1.03 **NARRATIVE OF REVISIONS** for attached drawings labeled as Delta # 1 Dated 08.21.2026 on the drawings and labeled as ADDENDUM 1 on the specifications per DSA requirements.

B26.014 CUYAMACA COLLEGE AUTO LIFTS RTEPLACEMENT

BUILDING K AUTO LIFTS REPLACEMENT PROJECT: 2026-07-15 DSA APPROVAL SET

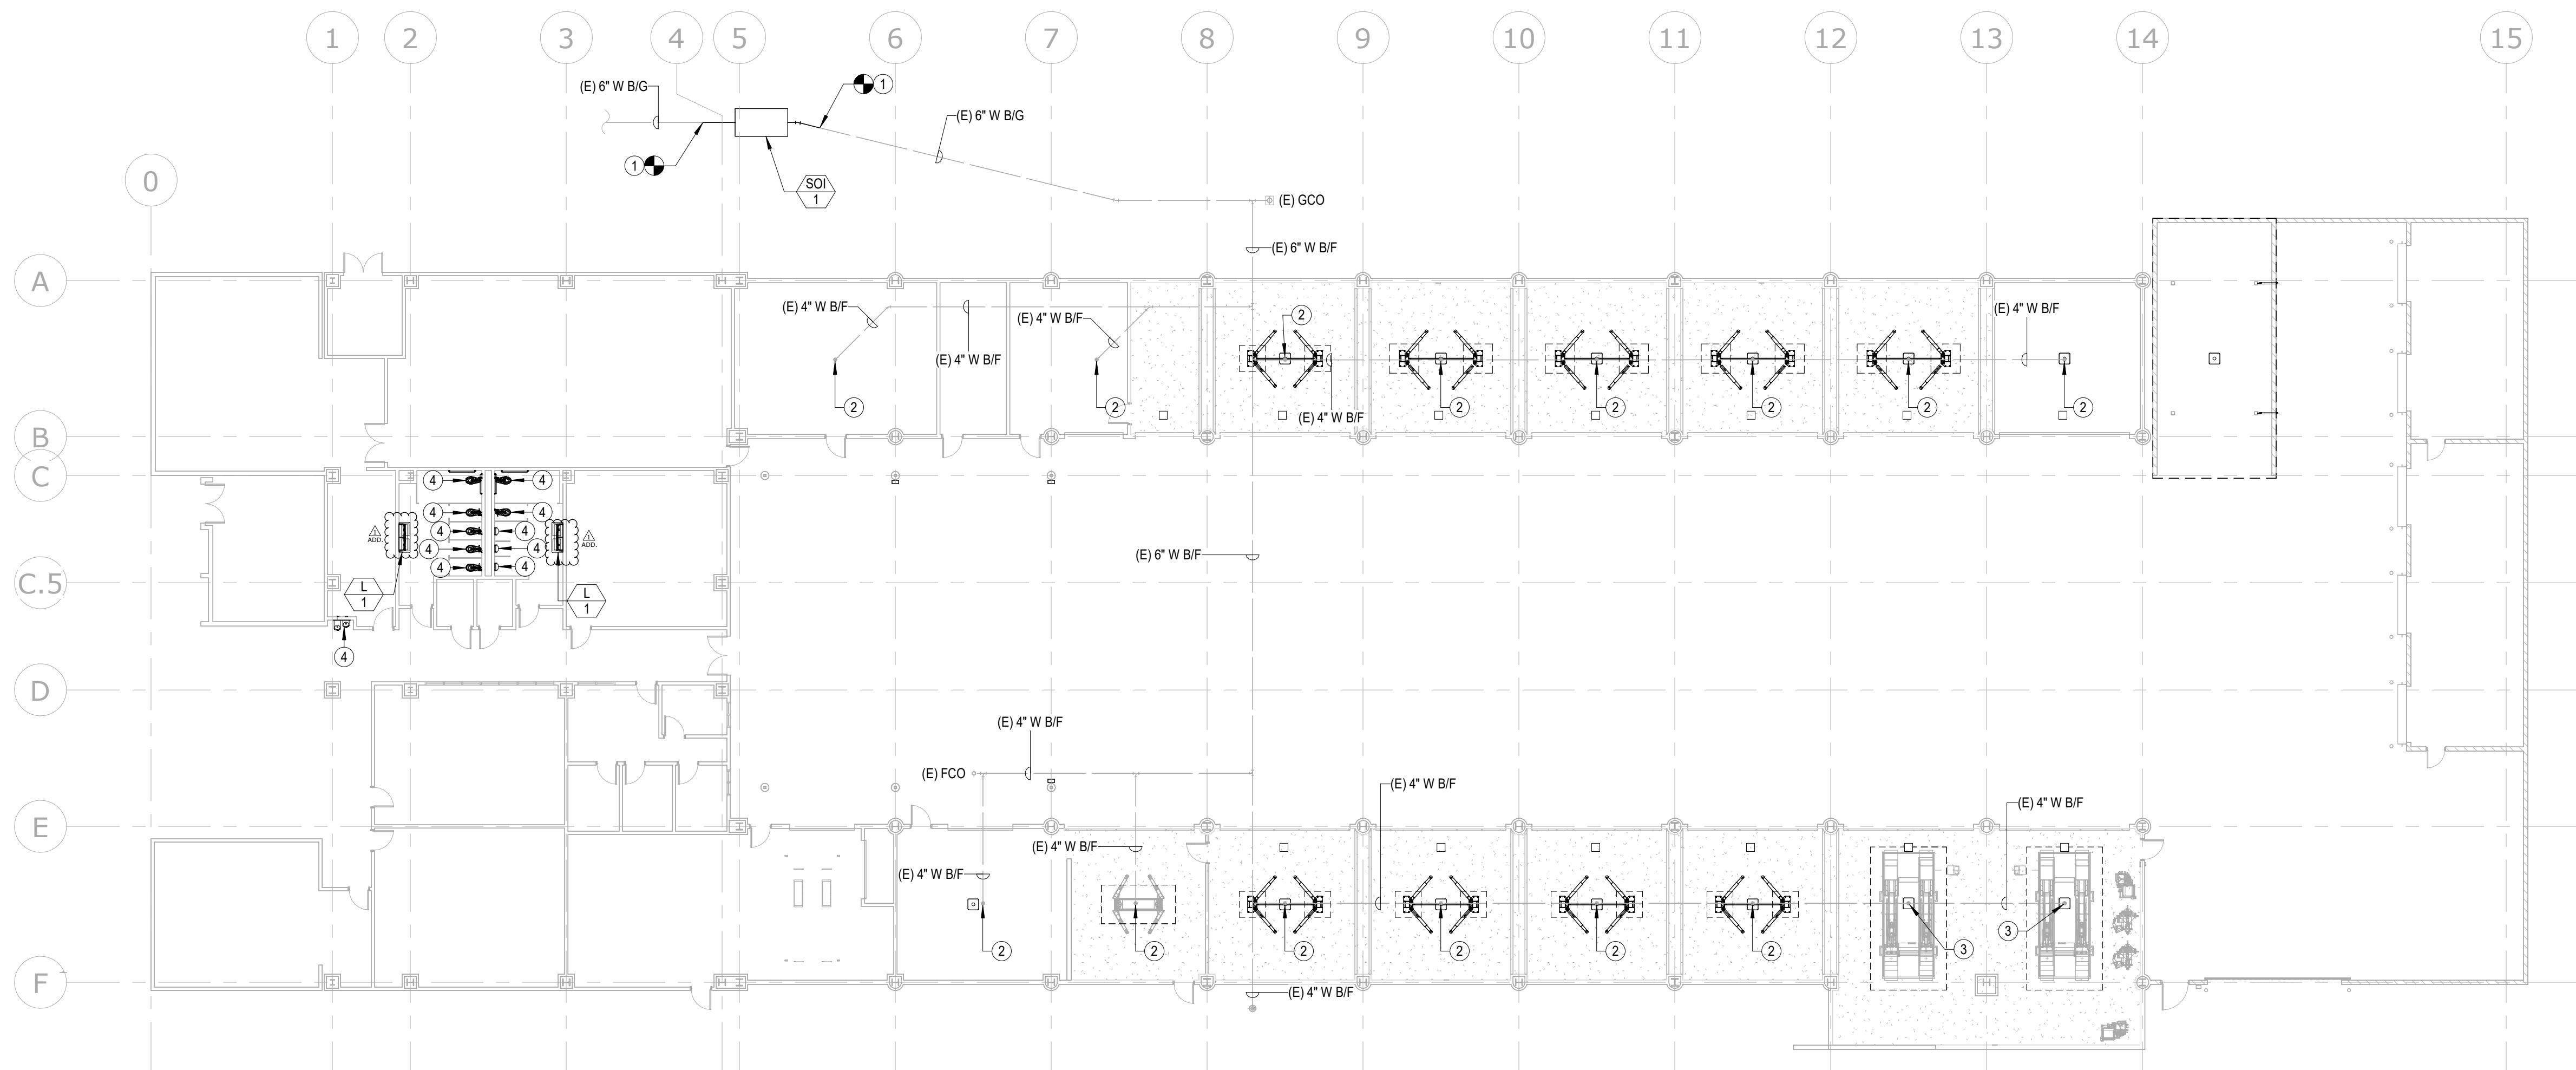
Item No. 1.9 Reference Sheet P1-2.0 – PLUMBING LEVEL 1 - OVERALL

- 1.9.1 Revise Sheet per clouded areas listed below:
(a) Revised lavatory model.
